Name of Proposed Development ADAMS SUBDIVISION

PLAT REVIEW

✓ Final Plat

"FINAL PLAT"

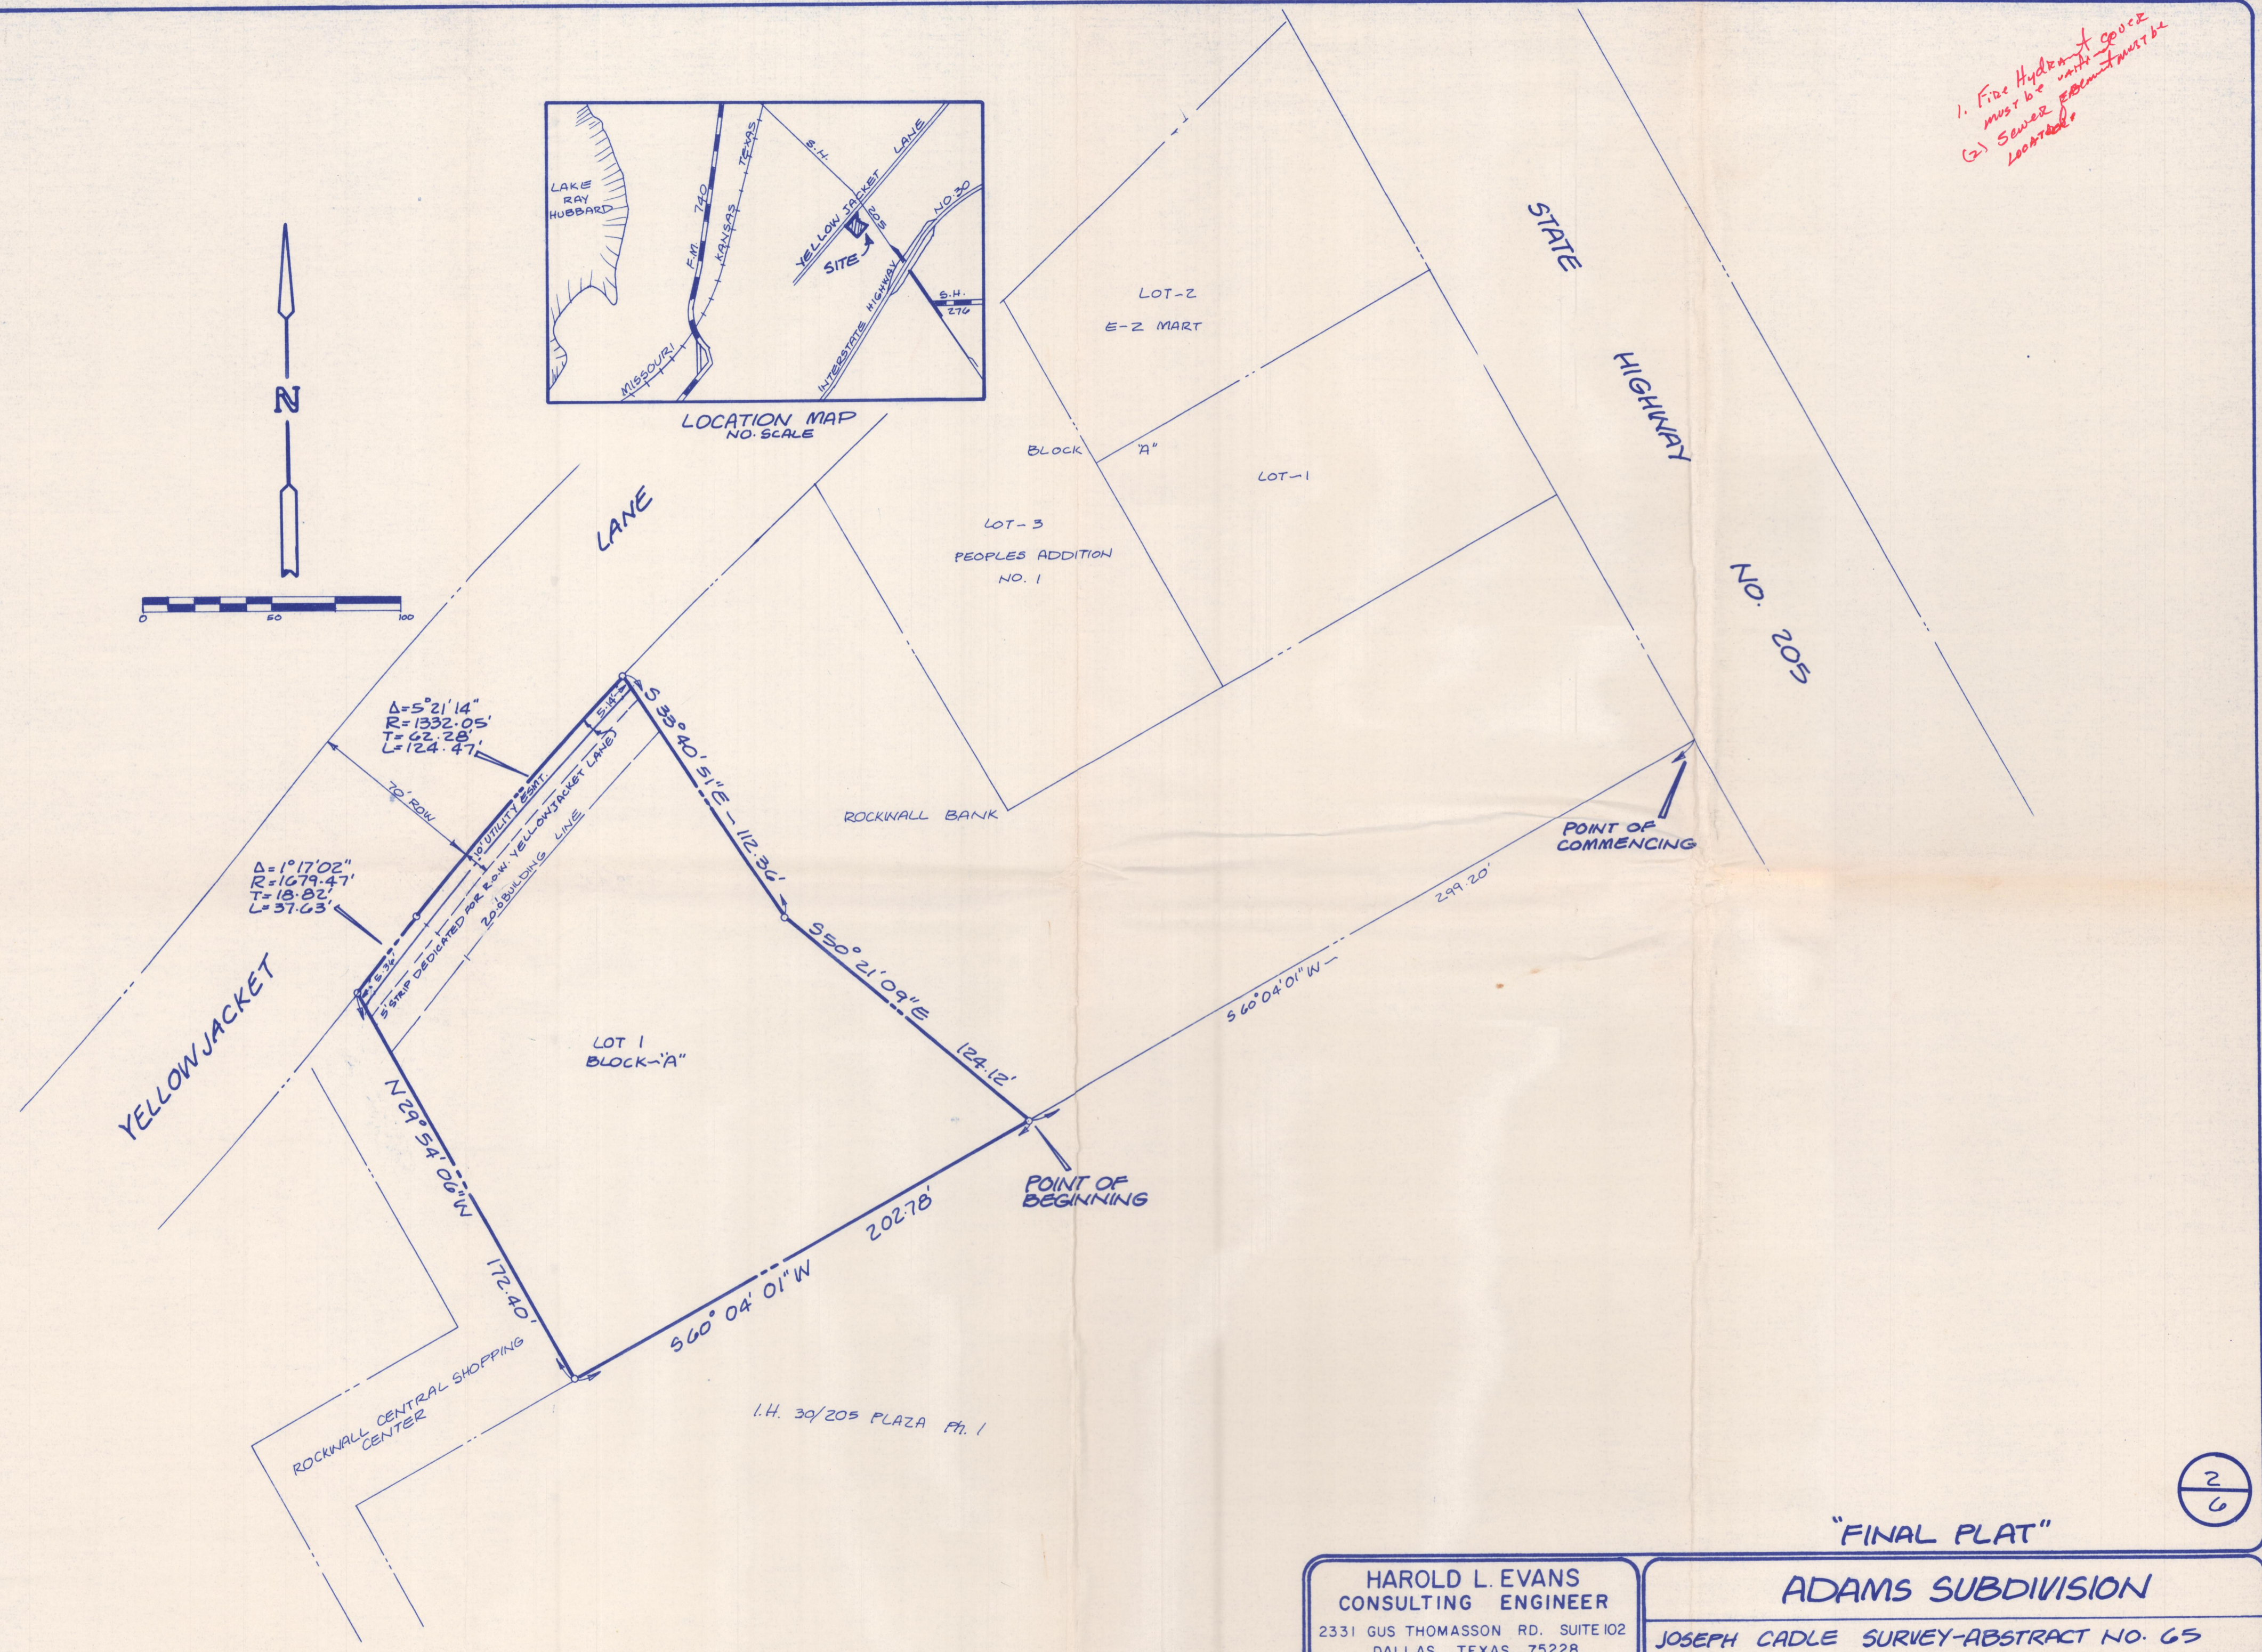
name of plat needs to be changed

1. Fire Hydrant & go over
must be within 100' of
(2) Sewer easement must be
located
